RECEIPT DATE: 4/21/22 **ONSITE SEWAGE DISPOSAL SYSTEM** P 571508  
 APPROVAL DATE: \_\_\_\_\_ **PERMIT: CONSTRUCTION** A \_\_\_\_\_  
 PROPERTY ADDRESS: 1431 Underwood Road  
 SUBDIVISION: Good Neighborhood LOT: 2 TAX ID: 03-352803  
 CONTRACTOR: SAMS CREEK EMAIL: SAMS.CREEK@AOL.COM  
 CONTRACTOR ADDRESS: \_\_\_\_\_ PHONE: 443 821 4932  
 PROPERTY OWNER: Ewell Malcolm W Trustee EMAIL: \_\_\_\_\_  
 OWNER ADDRESS: 1251 Underwood Road PHONE: \_\_\_\_\_  
 SEPTIC TANK SIZE (GALLONS): 1500 TANK MANUFACTURER: Babylon Vault  
 PUMP MODEL: Goulds 3885 PUMP SIZE WE05H PUMP TANK CAPACITY: 1500

**From:** Oswald, Hank  
**Sent:** Thursday, January 21, 2021 3:38 PM  
**To:** Ron Thompson  
**Subject:** OSDS Plan\_1431 Underwood Road

The following comments pertain to the review of the OSDS Plan for 1431 Underwood Road:

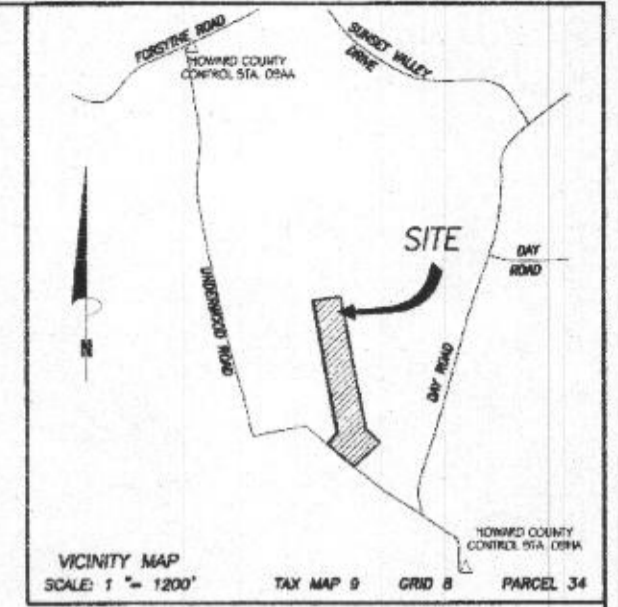
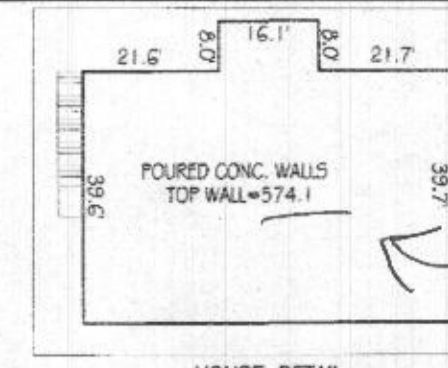
3.) Lateral length should be calculated with half a hole spacing i.e., T1-1 Lateral Length = 22.5 (not 20)

4.) On Lateral Detail, specify 1/2 hole spacing at manifold and end.

The lateral lengths have been corrected and an updated chart is included in the plan.

The plan now notes 1/2 spacing per the chart.
